DEPARTMENT OF TRANSPORTATION

Contract #: 04-0120F4Cty: SF/ALA Rte: 80 PM: 13.2/13.9File #: 69.28**WELDING INSPECTION REPORT****Resident Engineer:** Pursell, Gary**Address:** 333 Burma Road**City:** Oakland, CA 94607**Report No:** WIR-000622**Date Inspected:** 14-Sep-2007**Project Name:** SAS Superstructure**OSM Arrival Time:** 630**Prime Contractor:** American Bridge/Fluor Enterprises, a JV**OSM Departure Time:** 1530**Contractor:** Zhenhua Port Machinery Company, Ltd (ZPMC), Changxing Island **Location:** Shanghai, China**CWI Name:** Ye YongJun**CWI Present:** Yes No**Inspected CWI report:** Yes No N/A**Rod Oven in Use:** Yes No N/A**Electrode to specification:** Yes No N/A**Weld Procedures Followed:** Yes No N/A**Qualified Welders:** Yes No N/A**Verified Joint Fit-up:** Yes No N/A**Approved Drawings:** Yes No N/A**Approved WPS:** Yes No N/A**Delayed / Cancelled:** Yes No N/A**Bridge No:** 34-0006**Component:** Tower Mock-up 77 M**Summary of Items Observed:**

WELDING INSPECTION REPORT

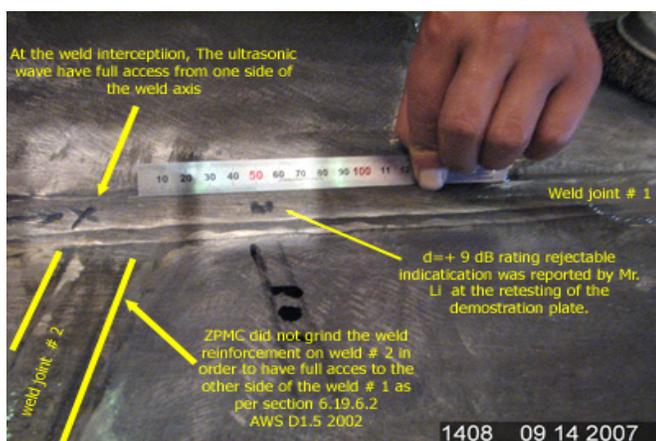
ZPMC scheduled a demonstration that will display that a sound weld could be achieved in compliance with the contract documents at a intersection of two different complete joint penetration (CJP) groove welds. The CJP weld intersection welded by ZPMC replicated a box girder connection. See digital photograph below of this intersecting CJP groove weld demonstration.

1. ZPMC did not perform the required lamination scan.
2. ZPMC used scanning levels lower than the required on AWS D1.5 table 6.3 tensile stress (18 dB in lieu of 25 dB).
3. ZPMC did not have the last revision of the ZPMC approved ultrasonic testing procedure available. ZPMC UT Procedure on site was dated 4/29/07.
4. ZPMC did not have a rejection acceptance criteria table 6.3 AWS D1.5 2002 available at the demonstration site.
